**Addendum Number Two**  
To The Drawings and Specifications for  
**SEDGWICK COUNTY – Waiting Room Addition**

Issued: Thursday, August 20, 2020

You are hereby instructed to include in your bids the following changes and/or corrections to the Drawings and Specifications for the **Waiting Room Addition to the Sedgwick County Corrections building located at 622 East Central.**

DRAWINGS ISSUED		
NO.	DATE	ITEM ISSUED
6	8/20/20	ADDENDUM 2
5	5/20/20	FOR PERMIT
4	5/14/20	PROGRESS SET
3	5/12/20	PROGRESS SET
2	4/24/20	PROGRESS SET
1	4/10/20	REVIEW

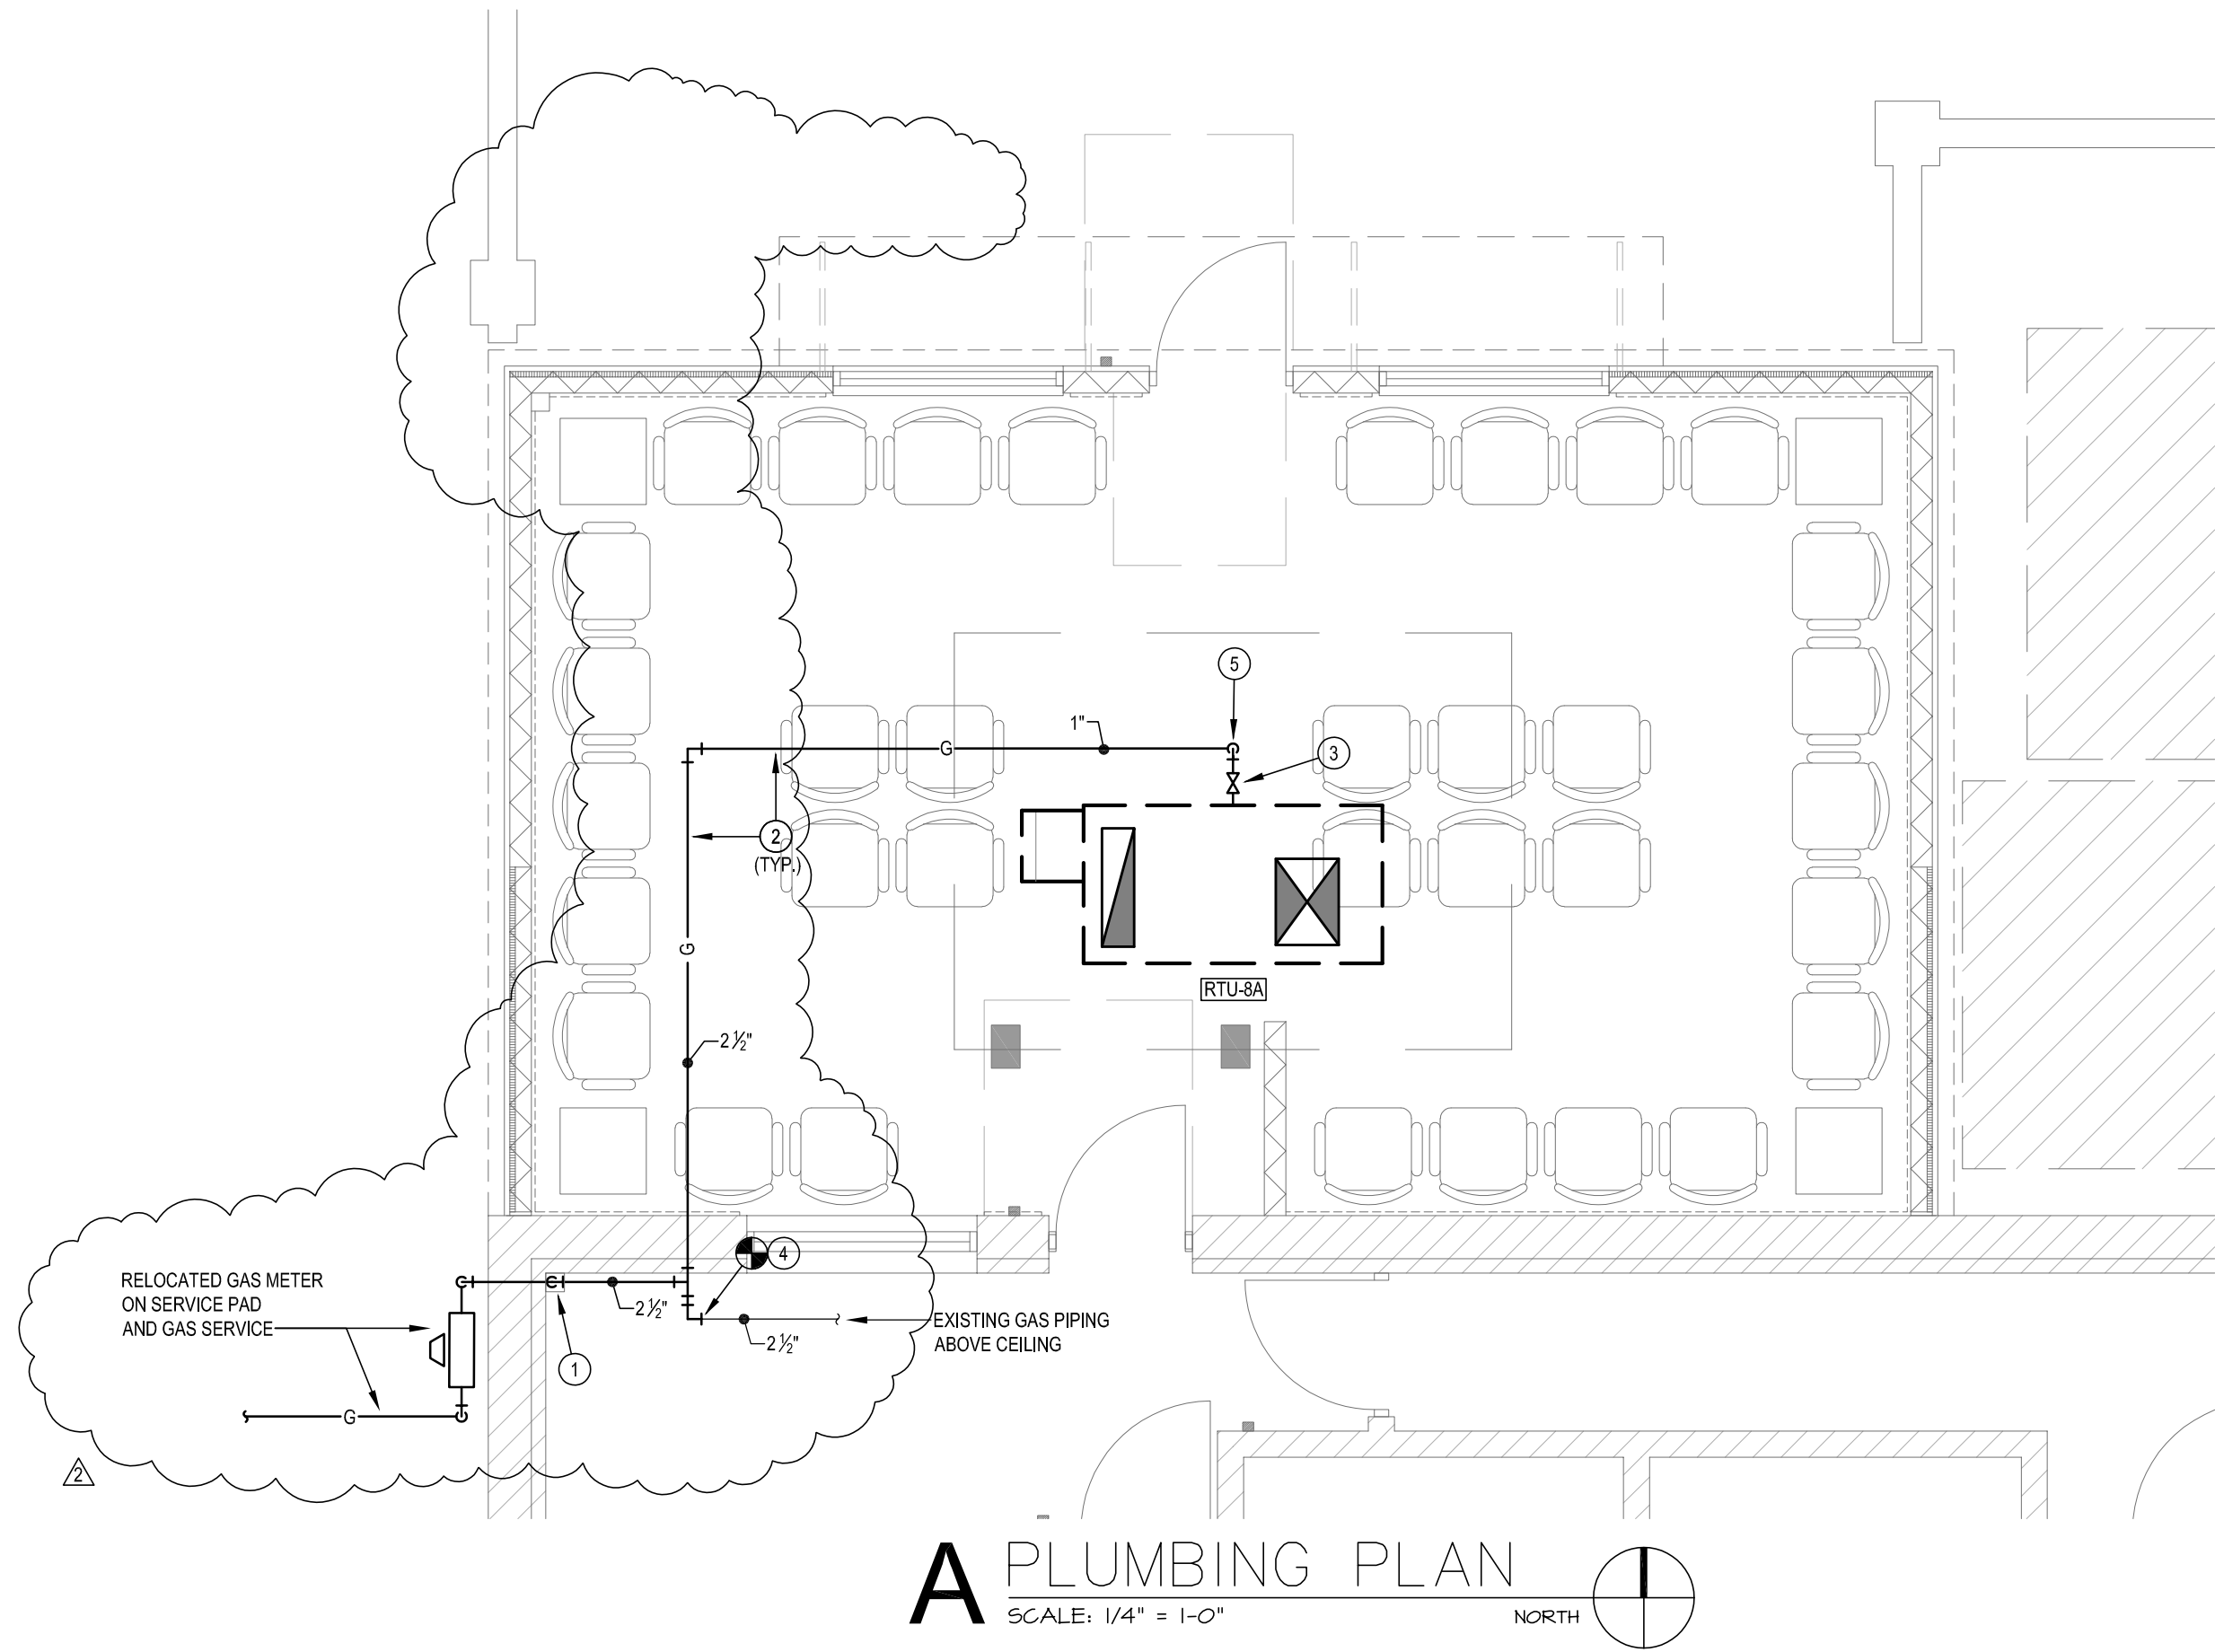
### 3.1 Sheet SP1.1

This sheet has been revised to show the new gas meter location. This sheet is reissued with this addendum.

- a. The Gas Meter shall be relocated to the West side of the existing building (in the parking lot). This will allow for the reconnection of the gas service prior to construction of the addition.

- b. The General Contractor shall pour pad on top of the existing paving for the gas meter and bollards to sit on. The pad shall be 4' square x a 6" thick concrete, reinforced with one layer of 6 x 6-W2.0 x W2.0 W.W.F. and #4 "L" bars at 24" o.c. drilled into the existing paving around the perimeter. The "L" bars shall be 12"x12".

- c. The General Contractor shall provide and install (2) 4" diameter steel bollards per the detail that is included with this addendum. The bollards shall be filled with concrete creating a domed top. The bollards shall be painted "safety yellow".
